1966 Corvette: Reliability Data Center Letter: Poor Release and High Pedal Effort - 1966 327 CID Corvette Engines

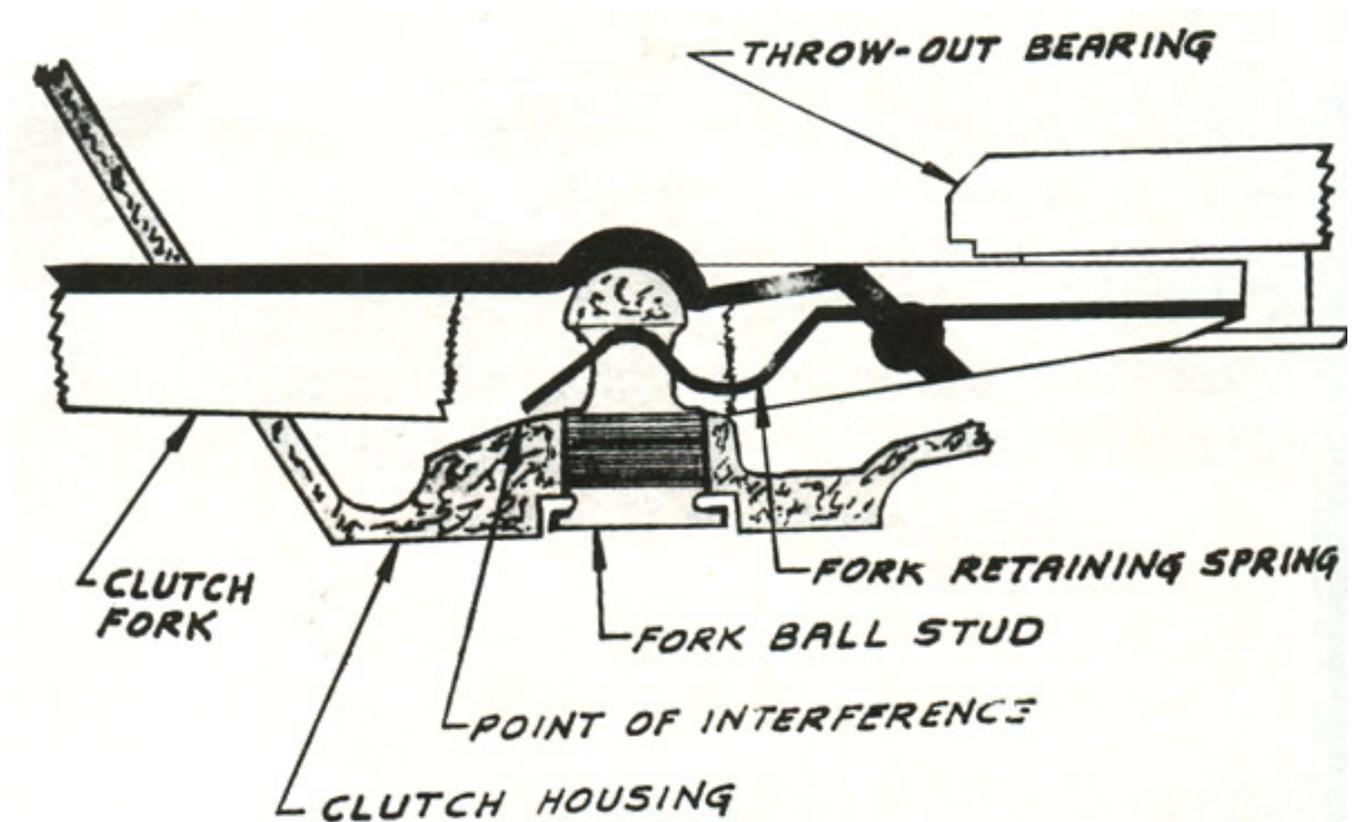
Recent investigation of poor release of clutch, high pedal effort and disc wear has isolated the condition to the clutch fork retainer tangs interfering with the clutch housing boss provided for the ball stud which causes a reduction in fork travel.

The above condition is caused by a short ball stud Part No. 3887159 which was used on 1966 327 CID Corvette engines until 4-4-66. At that time the past design ball stud part No. 3729000 was again installed and is currently being used.

In the event a complaint of high pedal effort or poor release is encountered the unit should be inspected for the above mentioned condition. (see attached illustration).

The correct ball stud Part No. 372900 has an overall length of 1 1/2 inches, the shorter stud, Part No. 3887159 is approximately 1 3/8 inches long.
